**From:** Brian Greenwood [REDACTED]  
**Sent:** 02 August 2012 16:44  
**To:** Mike Harris  
**Cc:** Able Marine Energy Park  
**Subject:** TR030001 - Associated British Ports [REDACTED] - proposed Able marine energy park - comments and further representations

PINS reference TR030001

**Response to Comments on Relevant and Written Representations and 1st Round Examiner  
Questions on Marine Matters**

Comments on AMEP Answers to ExA Questions and  
Response to Written Representations  
on matters of Rail Transport  
by Christopher John Geldard  
on behalf of ABP

**Figure PW1**

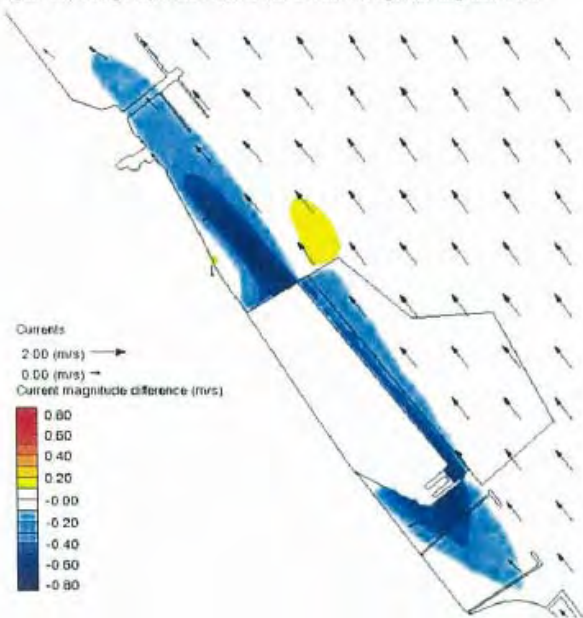
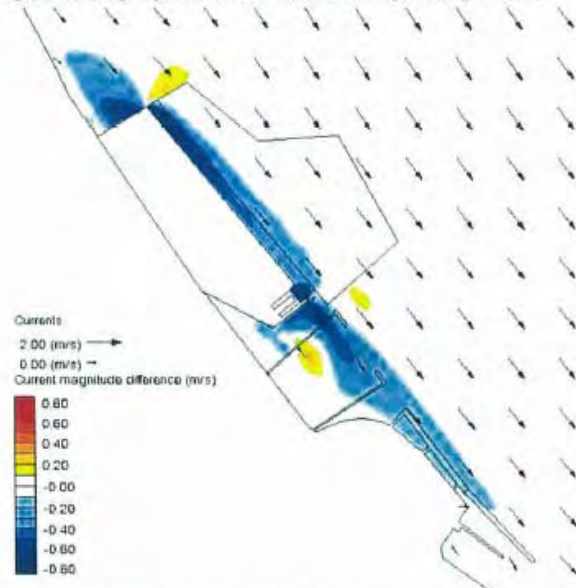
- 1.5. The Sunk Dredged Channel (SDC), see Figure PW1, is a critical passage for large vessels navigating to and from ABP and other estuary users facilities. It has a cyclic pattern of sedimentation with a consequent maintenance dredging requirement. The current status is that of a self-maintaining channel but it is reaching a point in the cycle when sedimentation is expected to rapidly increase. The last peak in sedimentation (1996/7) was so severe that for several months not even the continuous operation of two dredgers was able to keep the channel open for vessels at the previously maintained depth. Since that time, vessels have generally become larger and the Humber International Terminal (HIT) has been opened, hence more vessels requiring transit through the channel. The proposed annual volume of maintenance dredge arisings from the Able development to be deposited at HU080 (Middle Shoal) would substantially increase the risk that the SDC during the next period of peak sedimentation would be unavailable for vessels for a longer period of time. It is not possible to calculate the precise effect, but based on the relative increase in volume that is likely to be deposited during the peak sedimentation period it is estimated that the maintenance dredging requirement in the channel may be increased by 15 to 20%. Even more critical for vessel management will be the increase in rate of sedimentation (loss in depth) and the rate at which this can practically be removed. This would directly impact on access to the Port of Immingham for larger vessels and, unless comprehensively safeguarded, may leave the Port severely disadvantaged by Able's proposals.

FIGURE PW2

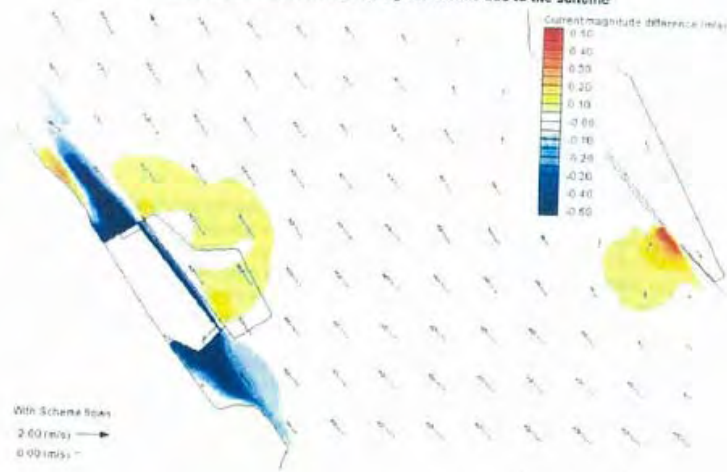
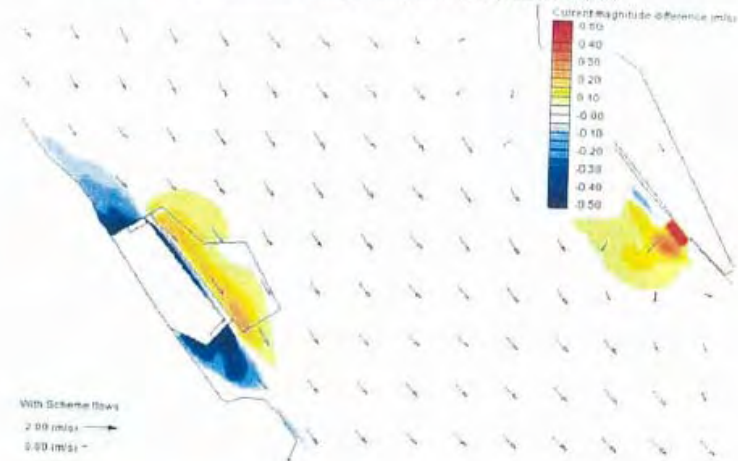
- 3.6. I observe that the applicant now notes ABP's concerns with respect to IOH. The applicant, however, still makes no comment about whether IOH was actually modelled in the baseline hydrodynamics.
- 3.7. A comparison of the June 2012 modelling results at Figures 3.9 and 3.10 of supplementary report EX 8.7 with the equivalent Figures 15 and 16 in the original ES demonstrates that IOH was not included in the original modelling. This is further substantiated by:
- Firstly, IOH was not shown or recognised as a sensitive receptor in the original ES; and
  - Secondly the pattern of change in the later modelled version is very different; see the attached Figures PW2 and PW3.

- 3.8. The argument put forward for no increase in sedimentation in IOH might be credible if the local baseline hydrodynamics had been correctly modelled and IOH had been correctly represented in the model. This does not, however, appear to be the case and the queries raised by ABP in this respect have not been answered by the applicant's response. If it had been included I would have expected to see the data from the model. This has not been provided.
- 3.9. The new report, EX8.7, is an attempt to justify the assertion that there will be no effect on IOH. However, comparison of equivalent diagrams from this new report and the original modelling presented in the ES, (Figures PW2 and PW3 respectively attached), show distinctly different

patterns of effect on the local flow regime. Figure PW2 is the new modelling with the DCO development design and Figure PW3 is the ES presented design, which was inferred in the ES as the worst case. It should also be noted that IOH and the jetty structures appear in the new modelling but are absent from the ES. This supports our view in 7.2 (b) of the Relevant Representations that the works have not been correctly reflected in the ES nor properly assessed. As I indicated in Para 1.1, I have not had an opportunity yet to determine whether the new modelling has been properly undertaken and support the assertions made about it and in particular whether it has properly assessed IOH and the jetty structures, assets that are critical to marine operations at the Port of Immingham.
